U.S. COMMISSION OF FINE ARTS PRESENTATION | APRIL 18, 2019

World War One Memorial

Response to Walkway, Lighting, & Sculpture Fountain Comments

SCULPTURE FOUNTAIN: DETAILING

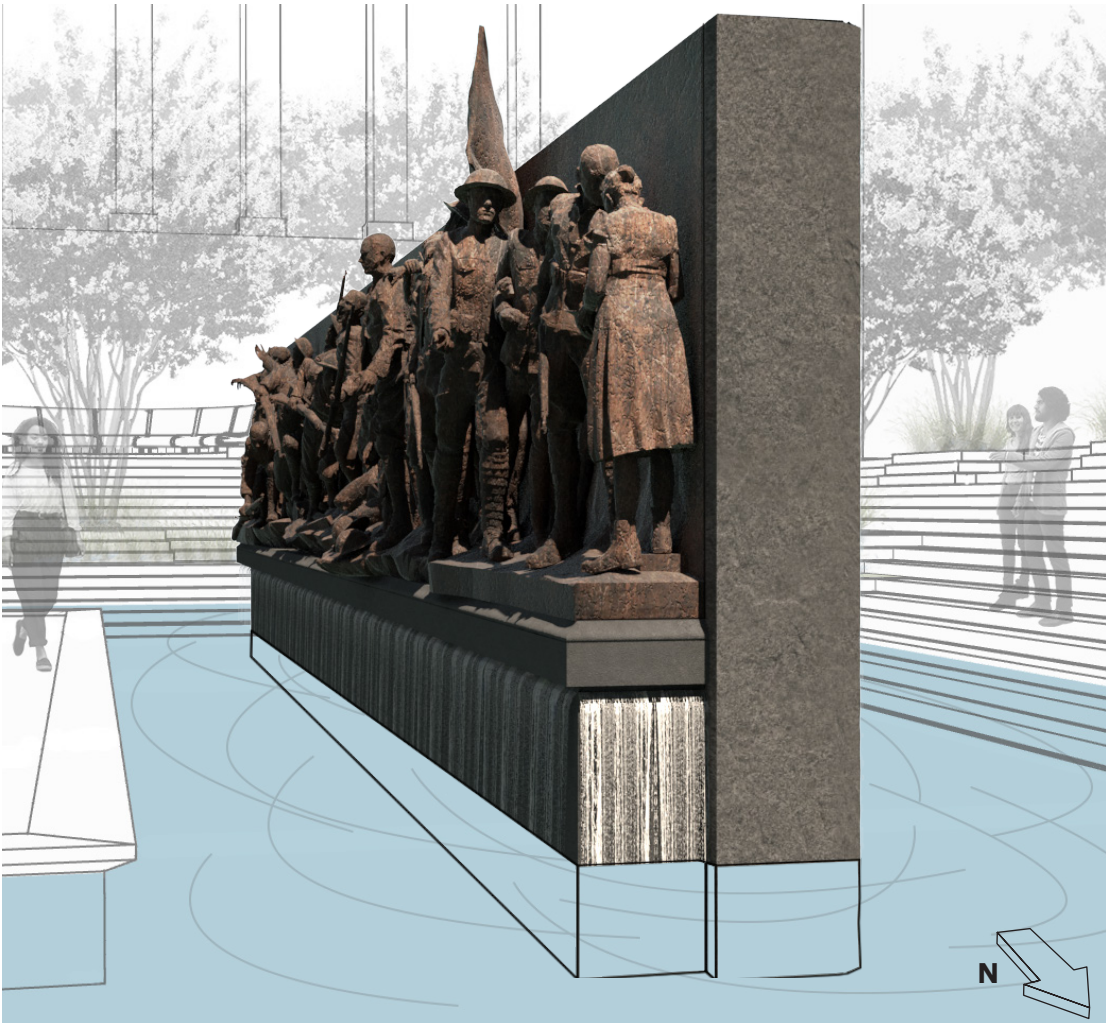
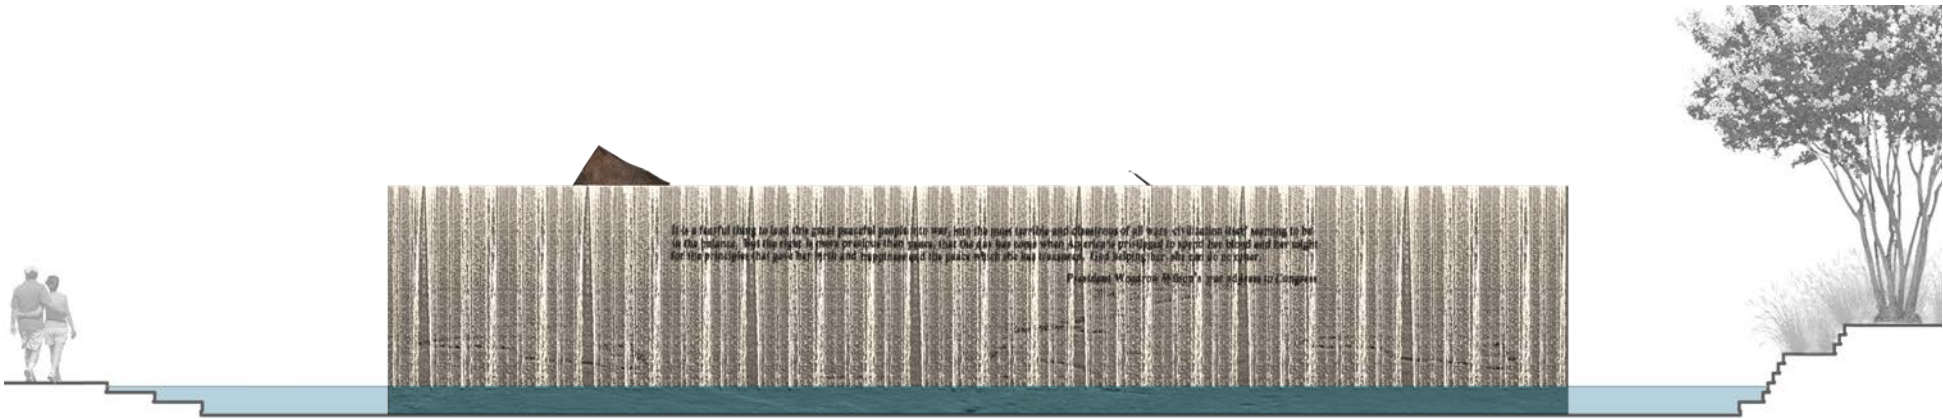
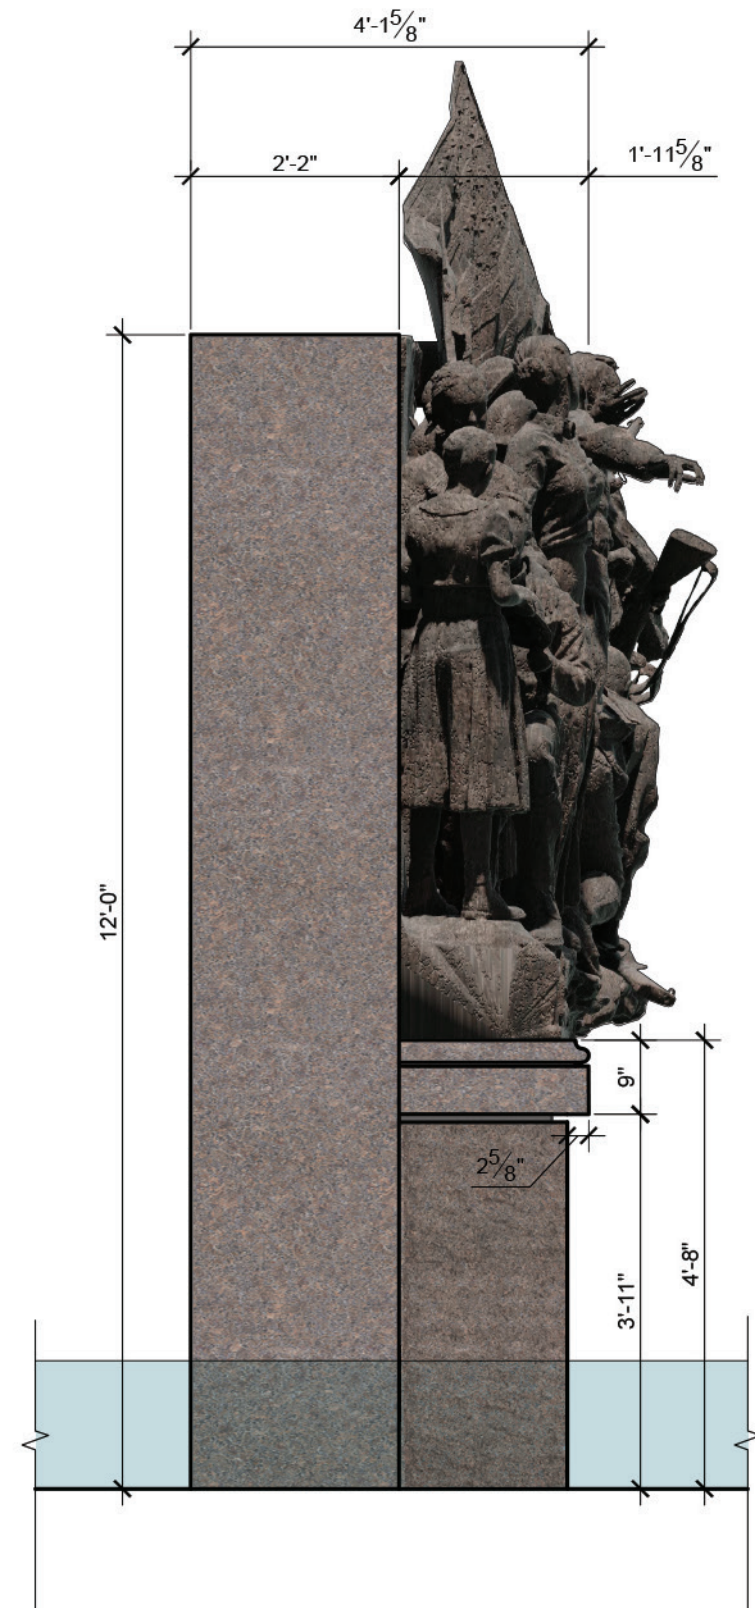
Directives + Responses October 2018 CFA

- Strong preference for the option in which the bronze sculpture rests on a stone shelf projecting above a recessed linear waterfall paired with the monolithic stone wall on the west side
- Further developed the preferred option
- Recommended developing the light quality and ethereal character by making the stone shelf as thin as possible and further recessing the waterfall
- Coordinated with structural and fountain team to develop the narrowest internal profile possible to support the bronze sculpture and desired cascade effects
- Preference for the darker granite to match the Pershing Walls
- Pursued the use of the Carnelian granite to match the existing Pershing Walls
